**Economic Commission for Europe****Inland Transport Committee****World Forum for Harmonization of Vehicle Regulations****Working Party on General Safety Provisions****116th session**

Geneva, 1–5 April 2019

**UN Regulation No. 26 (External projections of passenger cars)****Proposal for Supplement 4 to the 03 series of amendments to  
UN Regulation No. 26 (External projections of passenger  
cars)****Submitted by the expert from the International Organization of Motor  
Vehicle Manufacturers\***

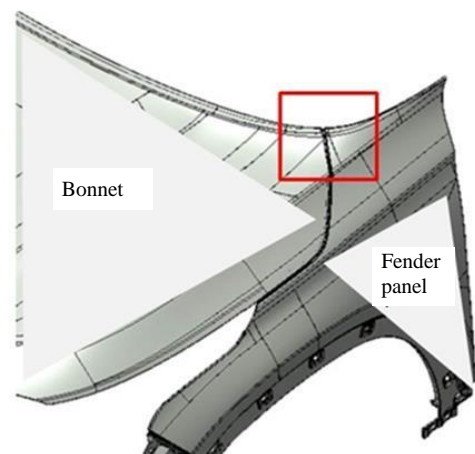
**The rear edge of the bonnet includes the extrapolation of this edge to the left and right (e.g. as upper edge of the fender or as edge of the a-pillar) and other inward facing edges of body panels not easily contacted by vulnerable road users may be blunted."**

3. This justification is valid in the same way for rear edges of fenders or rear edges of A-pillars if they extend from the rear edge of the bonnet to the left and to the right.
